Test Vectors for 800GBASE-ER1 FEC and PMA (Comment I-316)

Comment I-316 against D3.0

Proposed Text for Annex 186A

Figure 186A-1 Test vector points for 800GBASE-ER1 FEC

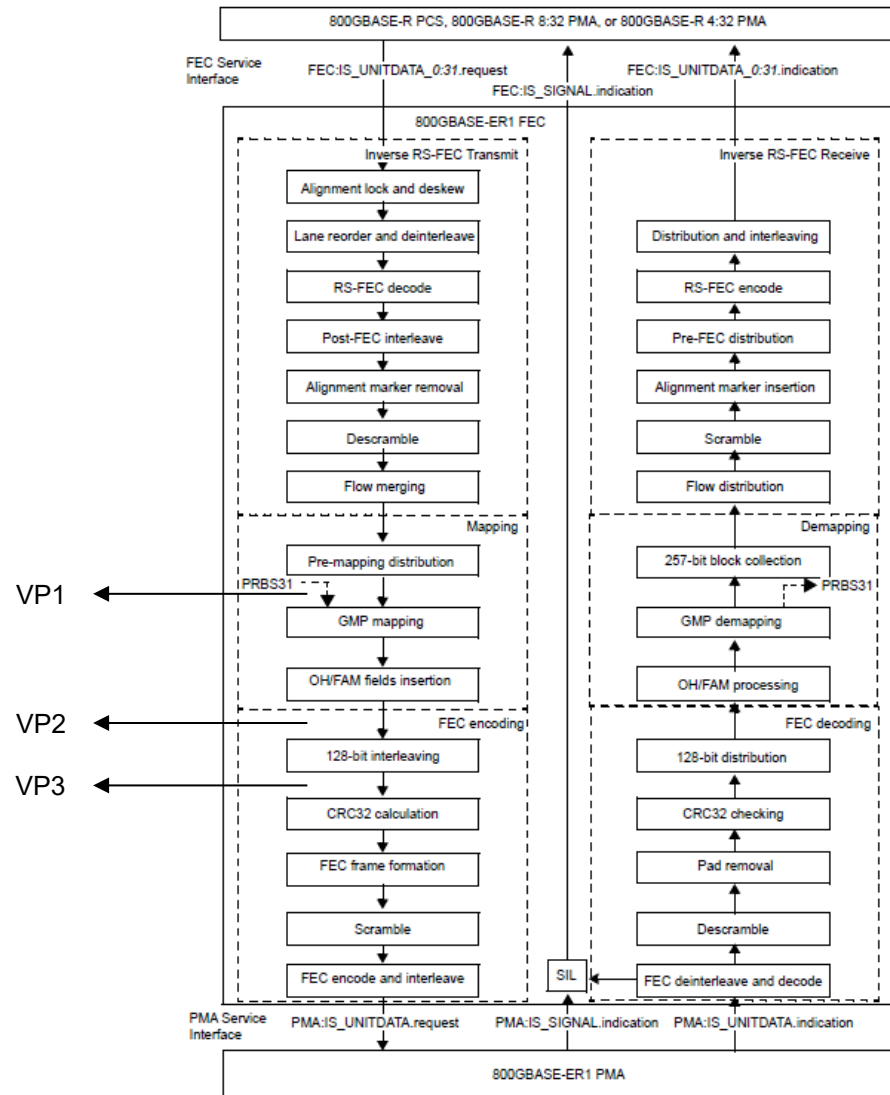
CI 186A	SC 186A	P954	L1	# I-316
Nicholl, Gary		Cisco Systems, Inc.		
Comment Type	TR	Comment Status	X	
As noted in Draft 2.2 Comment #44 (https://www.ieee802.org/3/dj/comments/D2p3/8023dj_D2p3_comments_final_clause.pdf), test vectors are required to be provided for the 800GBASE-ER1 FEC and PMA.				
SuggestedRemedy				
Two contributions will be provided:				
1) A contribution containing the test vectors. This will be based on the test vectors files provided against Draft 2.2 Comment #44 (https://www.ieee802.org/3/dj/comments/D2p3/8023dj_D2p3_comments_final_clause.pdf) and posted as https://www.ieee802.org/3/dj/public/26_01/sluyski_3dj_02_2601.7z .				
2) A contribution containing the proposed text for Annex 186A.				
Proposed Response	Response Status O

Test vectors are provided at test vector points VP1, VP2 and VP3 for the 800GBASE-ER1 FEC sublayer as shown Figure 186A–1. Test vectors are provided at test vector point VP4 for the 800GBASE-ER1 PMA sublayer as shown in 186A–2.

The test vectors at VP1 are at the input to the GMP mapper function defined in 186.2.3.3.

The test vectors at VP2 are at the output of 800GBASE-ER1 tributary frame overhead insertion function defined in 186.2.3.5.

The test vectors are VP3 are at the output of the 128-bit interleaving function defined in 186.2.3.6.
